INITIAL FIRE SAFETY INSPECTION REPORT

Fashion Pulse Ltd.

RSC ID: 26388

Date: 16-September-2025

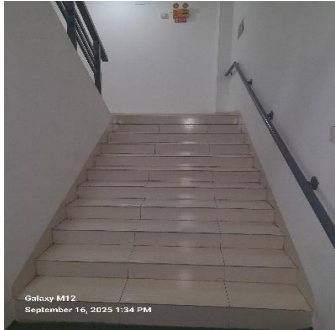
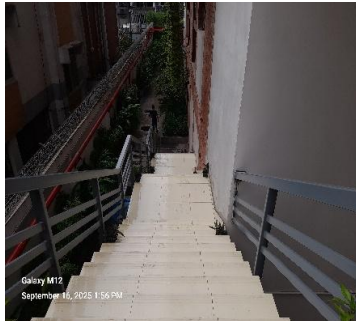
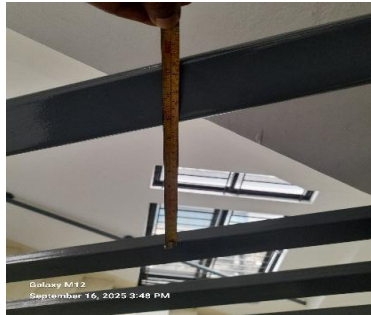
F-6	Means of Egress	Based on the number and location of emergency lights observed, adequate illumination levels are not anticipated along egress routes. Location(s): All floors of the building-01	Test the emergency lighting system on each floor and provide additional emergency fixtures to provide adequate illumination along the means of egress. Provide a minimum illumination of 10 lux at the floor level within exit stairs and exit discharge paths and minimum 2.5 lux along exit access aisles. Illumination on means of egress shall meet in accordance with RSC Technical Guidelines (Standard)¹ V1.0 Section 10.12.2.	Within 3 Months

F-7	Means of Egress	Exit stairs serve more than 5 stories and do not have required reentry provisions on all floors. Location: Building-01	Every door in a stair enclosure serving more than 5 stories shall be provided with re-entry unless it meets RSC Technical Guidelines (Standard) ¹ V1.0. Section 6.8.3.1.	Within 3 Months
F-8	Means of Egress	Stair clear width was found less than 60 in. Location: South side exit stair on ground floor of the building-1 Available Stair Width: 55inch.	Stairs shall have a minimum clear width of 60 in for all industrial occupancies as per RSC Technical Guideline (Standard) section of 6.5.6	Within 3 Months

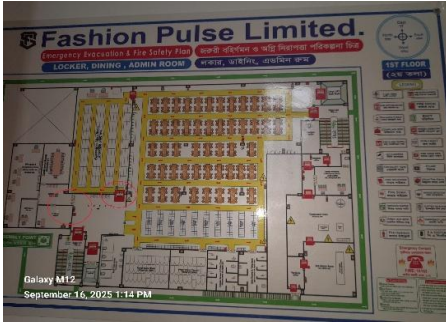
F-14	Fire rated construction	Areas used for in-process storage of combustible materials are open to the surrounding occupancy. Location: 5th & 6th floors of the building-01	Provide defined storage areas and limit the storage arrangement as follows: Maximum height of 2.45 m and maximum area of 23 m² and is separated by a minimum 3.0 m (10ft) from other storage areas and they do not exceed 10 percent of the building area of the story in which they occur. or, If sprinkler protected, Maximum height 12 ft (3.66 m) and maximum area of 1000 ft² (93 m²) and separated by at least 25 ft (7.62 m) and does not constitute more than 10 percent of the building area or 4000 ft² (372 m²) of the sprinklered area, whichever is greater. or, Enclose the storage area from the surrounding occupancy with a minimum 1 hour construction.	Within 3 Months
------	-------------------------	--	--	-----------------
